Z-90
(2014)

PETITION NO.: Z-90

PROPOSED USE: Petroleum Operations

ZONING COMMENTS:

Z-90

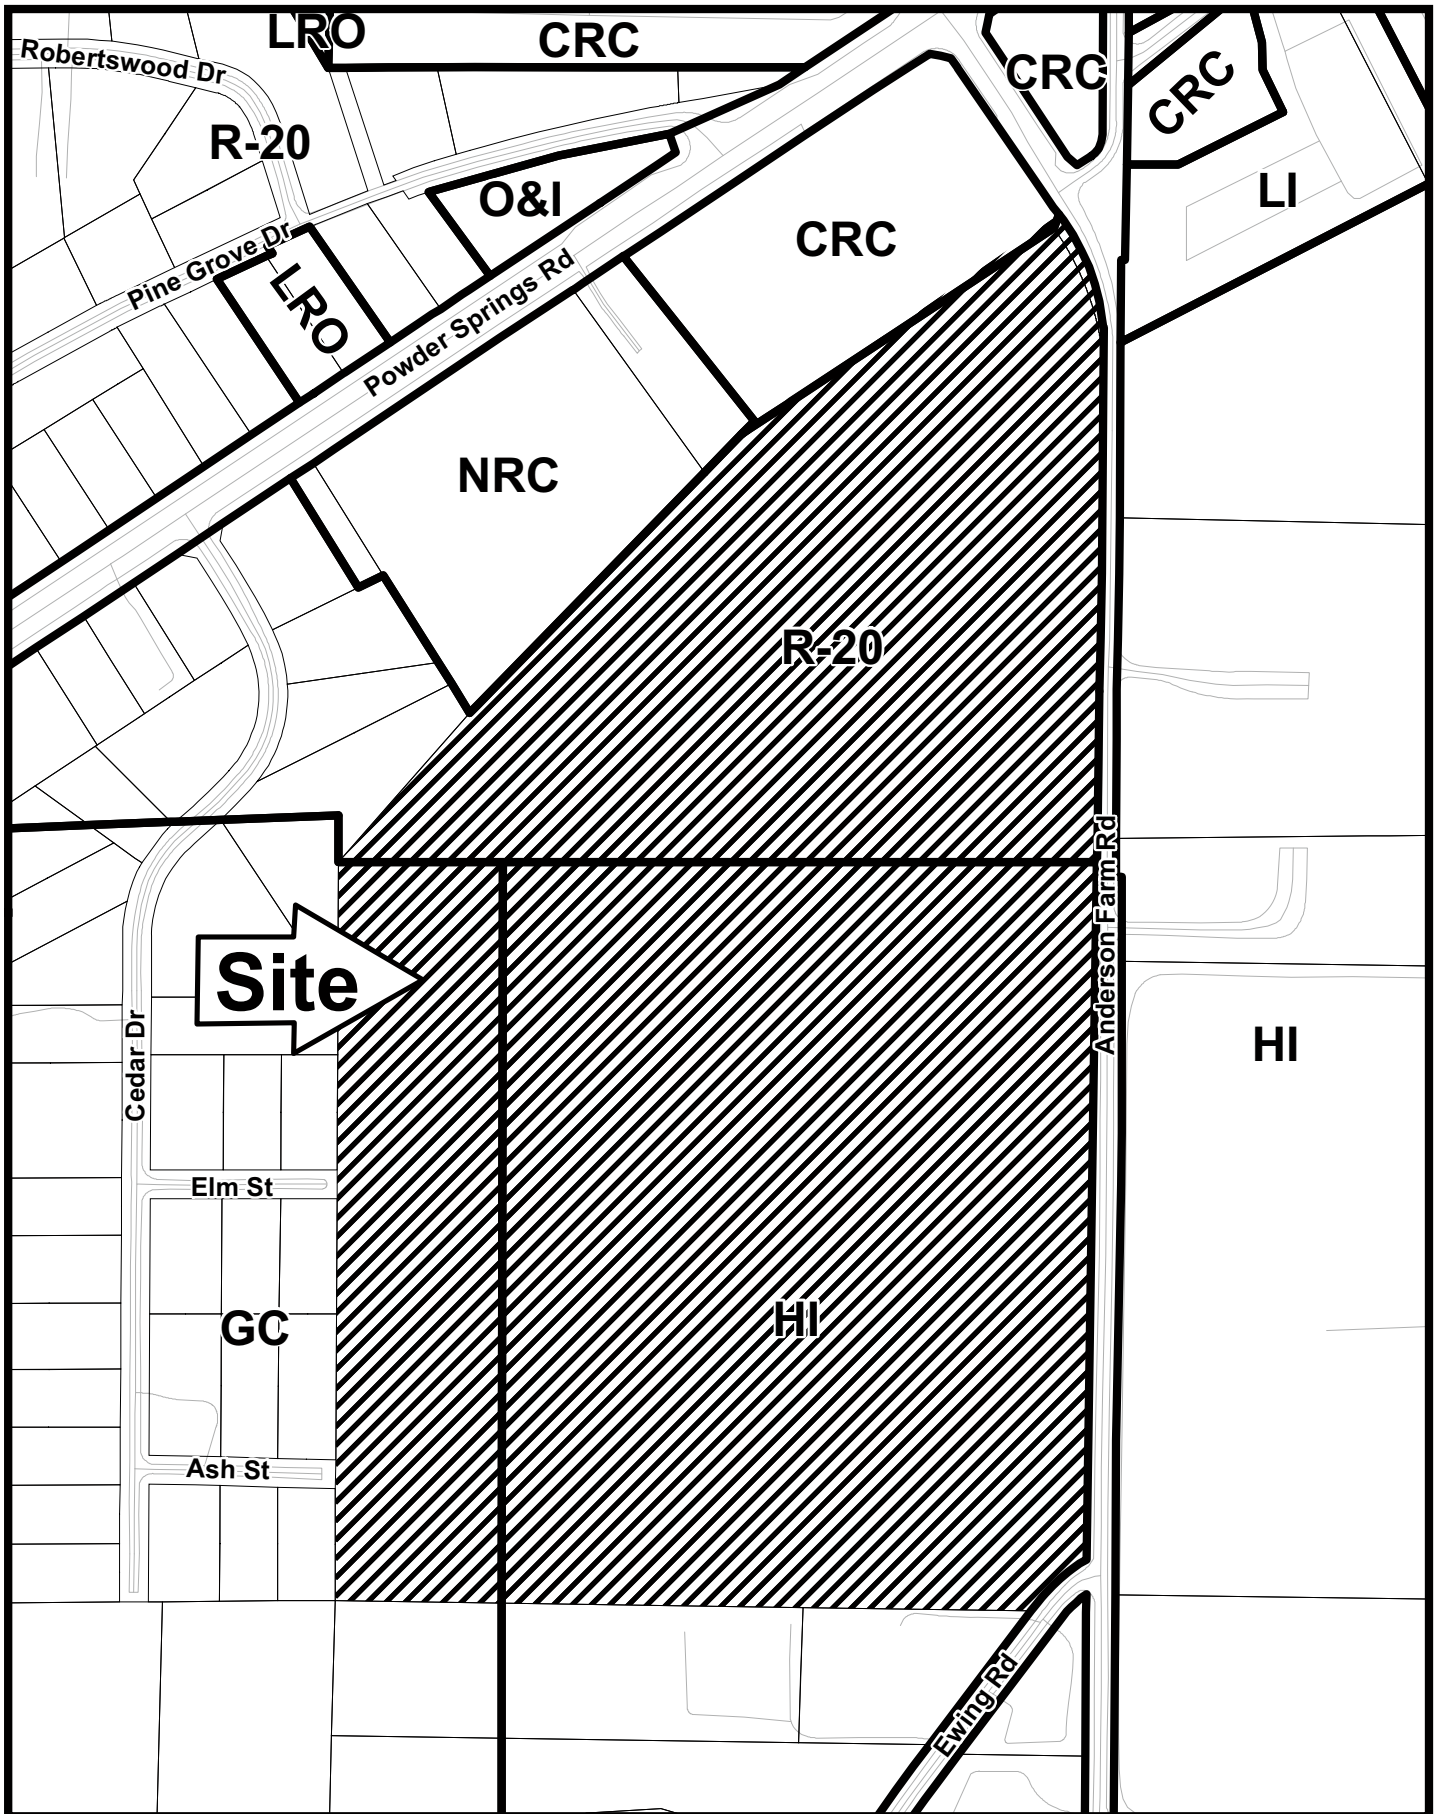
The applicant is requesting a rezoning from the current R-20 single-family residential district, GC general commercial district, and HI heavy industrial district to HI for Colonial Pipeline’s “Apple Orchard.” This property is the 58+ acre tract that lies directly adjacent to Colonial’s Atlanta Junction (“tank farm”) and is separated from Atlanta Junction by Anderson Farm Road. The rezoning will allow the applicant to construct a new offloading area, new storage, piping, and other related equipment which will complement the existing operations at the Atlanta Junction facility.

The site will consist of three (3) buildings (control building, testing facility, and office), six (6) offloading spots for offloading butane into the storage system, two (2) 60,000 bbl (working capacity) spheres each 90 feet in diameter, and eight (8) vertical can pumps. The storage spheres are situated so as to accommodate the required 1,000 foot offset from adjacent residential properties. There will be a total of six (6) full time employees working in shifts, 24 hours a day.

1. A waiver of the maximum structure height from 50 feet to 110 feet for the storage spheres (Sec. 134-231 (7))
2. A waiver of the limitation on hours of operation to daylight hours to allow for 24 hour a day operation (Sec. 134-231 (11))
